Re: Addendum Number 2 to our Environmental Impact Study for Muskoka Royale College, Responding to the July 14, 2019 Peer Review Comments; Our File 3517

Table 1. Peer Review Response

Table 1. Peer Review Response.

**APPENDIX H– UPDATED COPY OF FIGURE 4 FROM THE
EIS REPORT, PROVIDING A LEGEND FOR
THE ELC CODES**

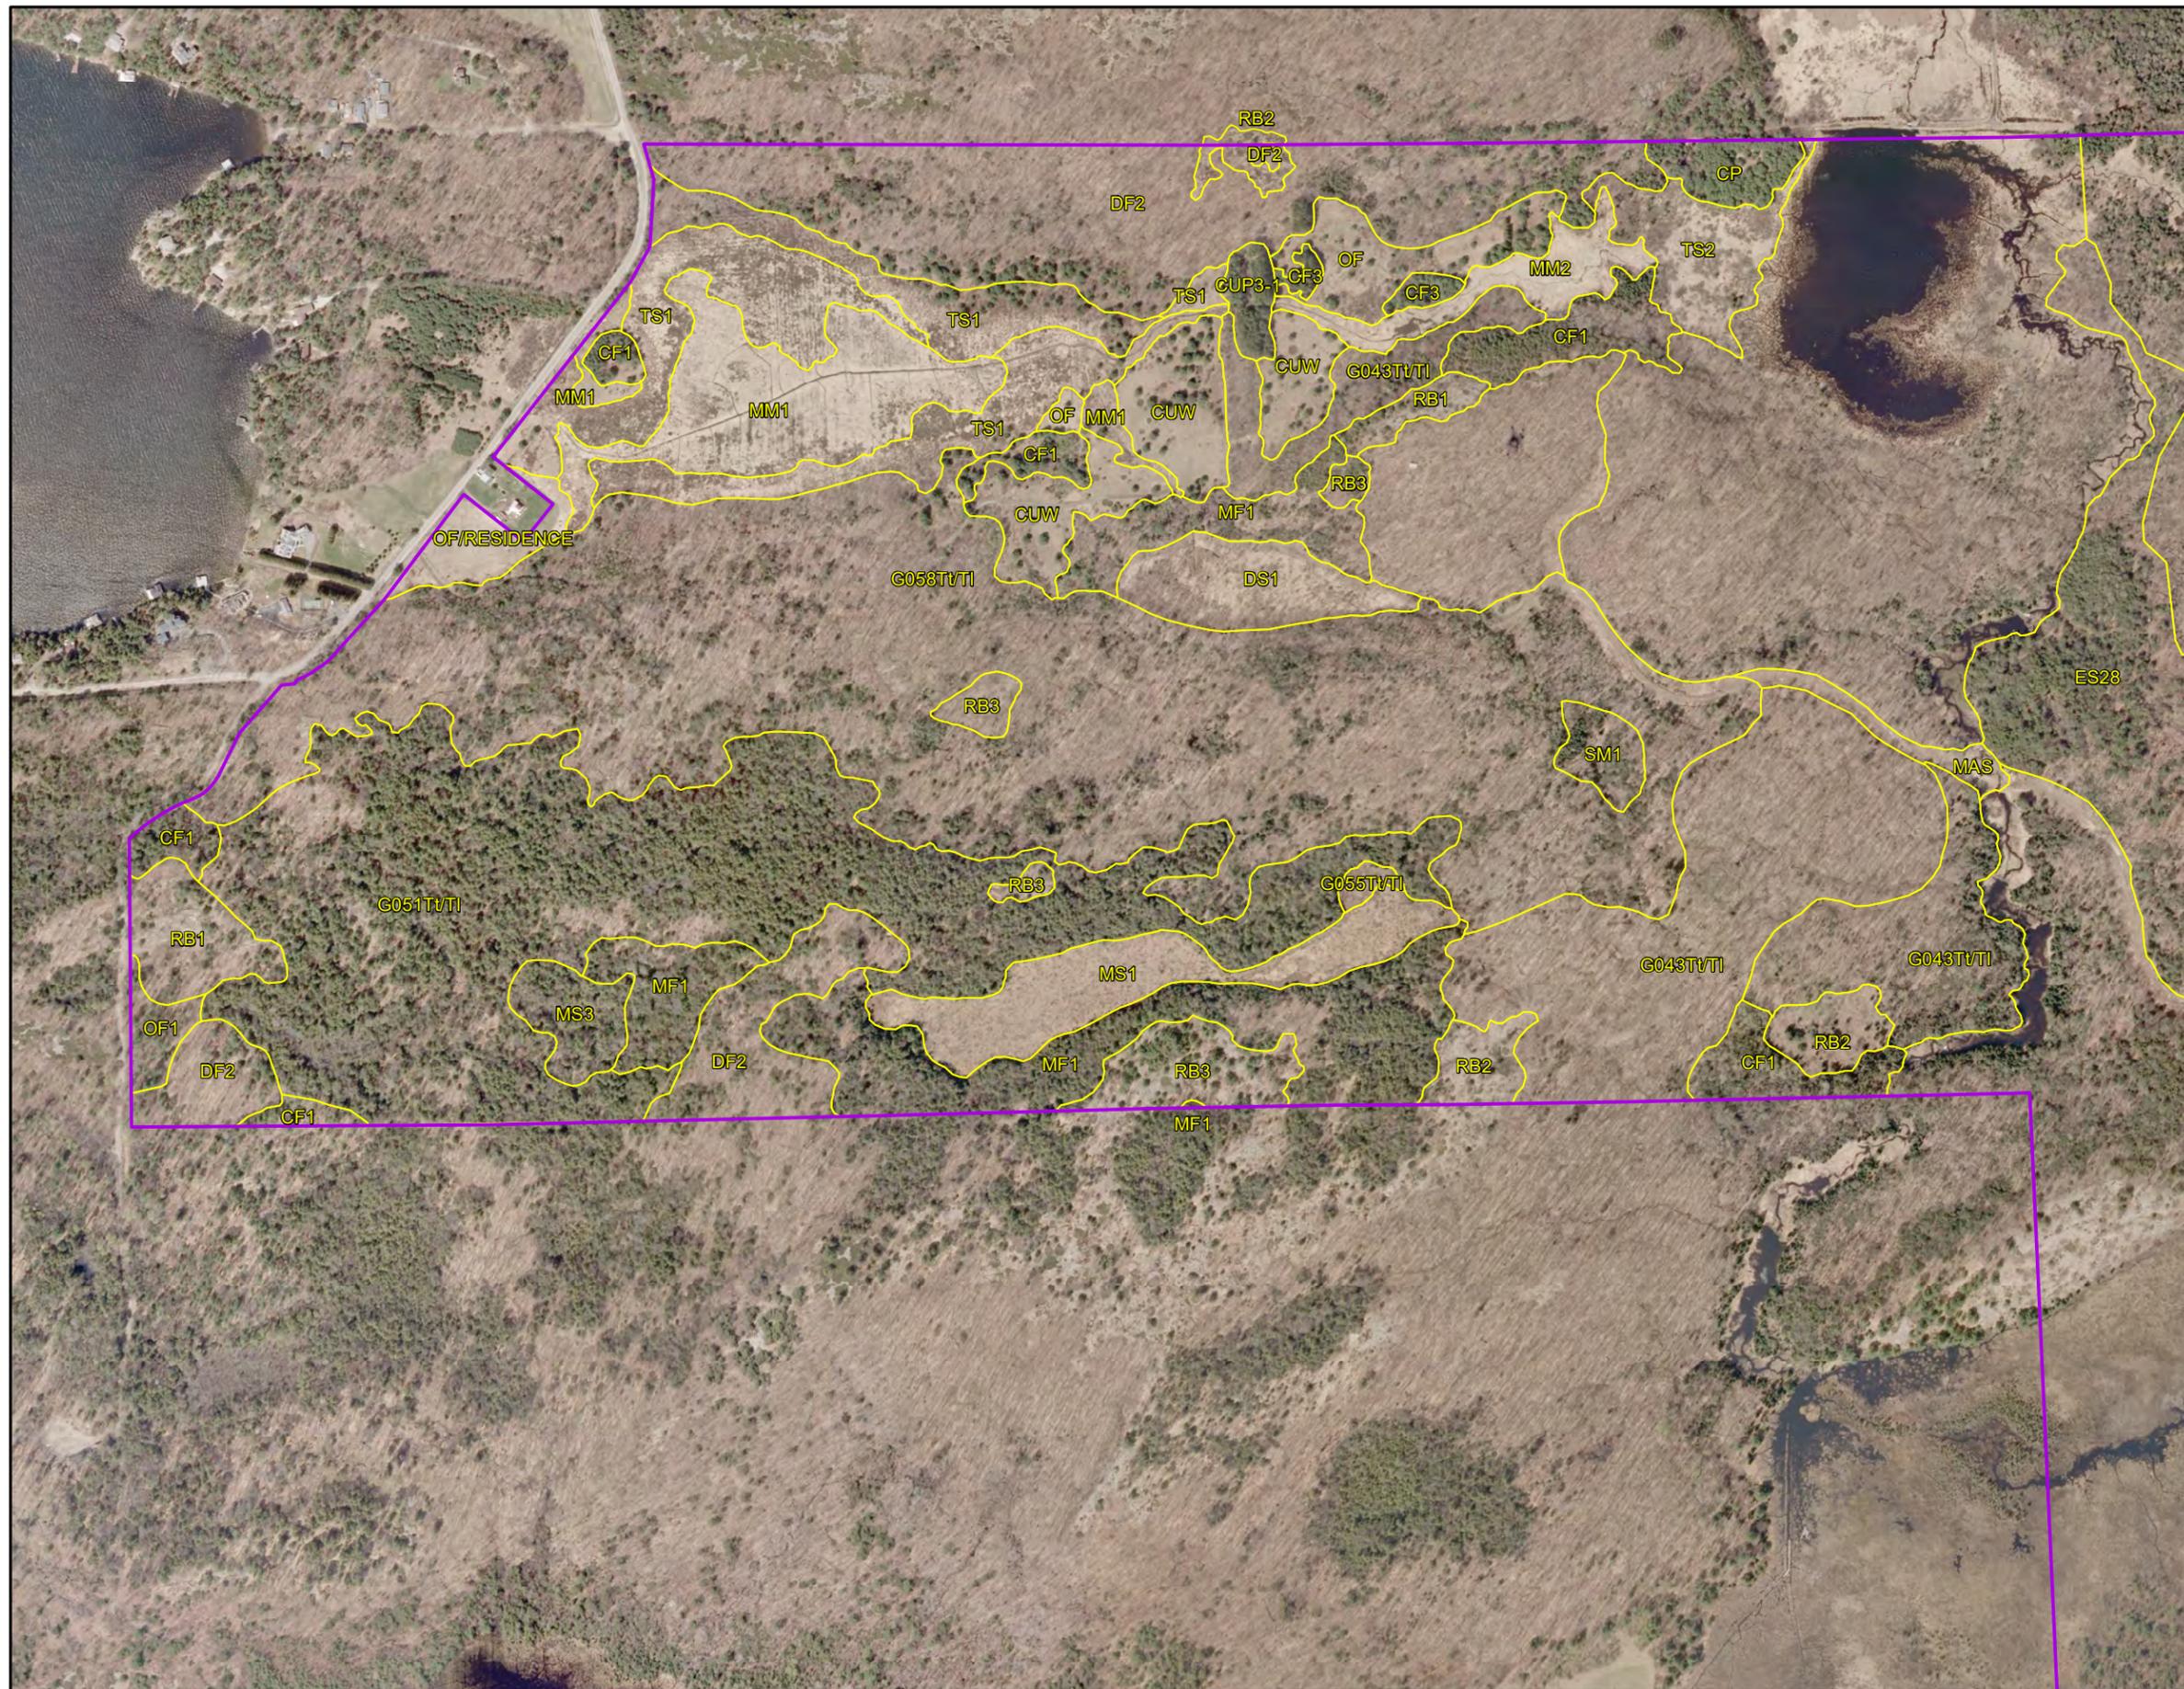
| HESL Peer Review Recommendation # | Updated Recommendation From HESL | MNAL Response | Additional Comments from HESL |
|-----------------------------------|--|--|-------------------------------|
| 28 | Please clarify Figure 4 so that the ELC codes can easily be read and interpreted with a legend. | Appendix H includes an updated copy of Figure 4. | |
